RE: **Maverick at University & Menaul**
1901 Menaul NE
Conceptual Grading Plan Stamp Date: 5/22/19
Hydrology File: H15D068

Based on the submittal received on 5/31/19, this project cannot be approved until the following are corrected:

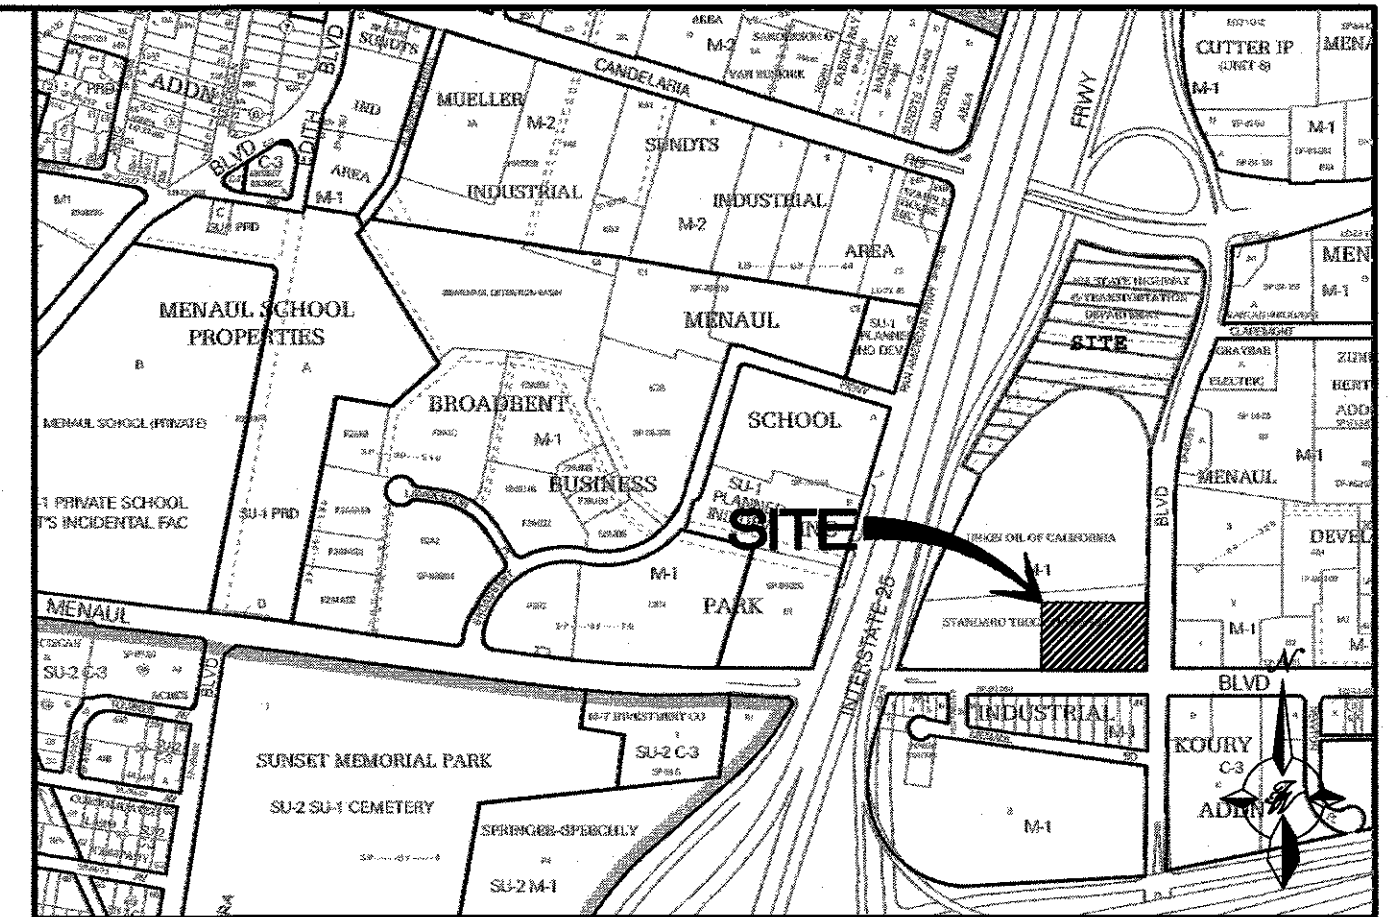
1. Existing and proposed contours need to be labeled.
2. There are 3 type-D inlets at the truck fueling entrance, not 2; all will need to remain; also show the work to remove and replace the damaged/destroyed valley gutter and include on the Infrastructure List.

3. Show the work in the ROW to remove the extra driveways. Also the curb and gutter in Menaul that is damaged/destroyed and will need to be replaced along the entire Menaul frontage; include this work on the Infrastructure List.

4. Show the existing onsite inlets and onsite storm drain to be removed.
5. Include a trenching prism for the private storm drain along Menaul, showing that the 10' easement is adequate and the prism won't encroach on the ROW.

6. Provide waterblocks at least 0.87' high at all entrances and include supporting spot elevations.
7. Include project benchmark and datum; include legal description.

8. Add note on the plan that "No work shall be performed in the public ROW without an approved Work Order or Excavation Permit."

9. Remove all "Conceptual" markings.
